## AGENDA MEMORANDUM

**Title:** **Dawson Trails Filing No. 2, Tract Q, Site Development Plan**  
[55.98 acres, located south of Territorial Road and west of Dawson Trails Boulevard]

Figure 3: Dawson Trails Planning Area B1 Site Development Plan

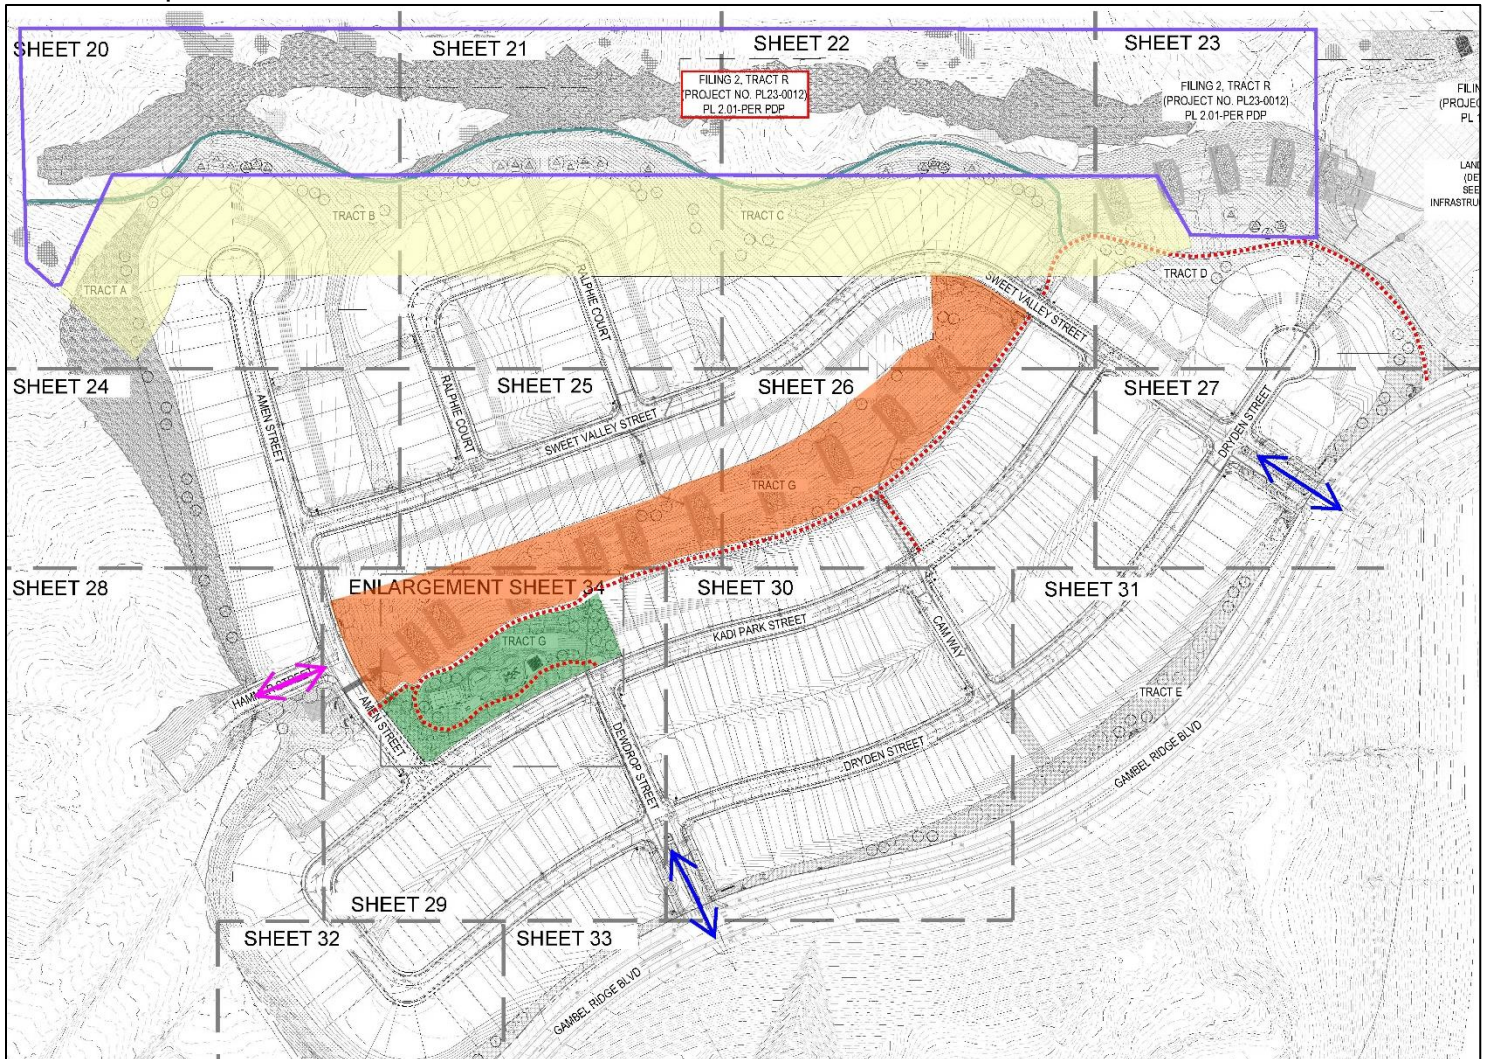
The SDP proposes 229 single-family detached residential units and 15 acres of private open space, which includes the neighborhood park (Figure 3, shaded green). Tract R (Figure 3, outlined in purple) is a minimum 250-foot open space buffer that separates this neighborhood from the Twin Oaks subdivision to the north. Tract R is part of a larger open space buffer that extends around the perimeter of the PD that will include a natural surface trail (Figure 3, solid teal line) and drainage improvement to be constructed by the developer.

A 150-foot wide transition zone (zone) exists along the northern tier of lots in PA-B1 (Figure 3, shaded yellow). The minimum lot size within the zone is 6,600 square feet (sf). This minimum lot size within the zone proposed with this SDP is approximately 7,700 sf.

There are two median separated access streets from Gambel Ridge Boulevard into the neighborhood (Figure 3, blue arrows). When the western half of Planning Area B1 is constructed, an internal collector road will connect the two neighborhoods and providing additional points of access to both neighborhoods (Figure 3, pink arrows).

Tract G is approximately 5.7 acres that traverses the neighborhood east to west and is a natural drainage channel that will serve as an internal buffer between within PA-B1 (Figure 3, shaded orange). The channel will be stabilized with the construction of this neighborhood.

An internal concrete trail is planned (Figure 3, red dashed line) that will traverse the neighborhood east to west. The trail will be extended west with the construction of the neighborhood in the western half of PA-B1.
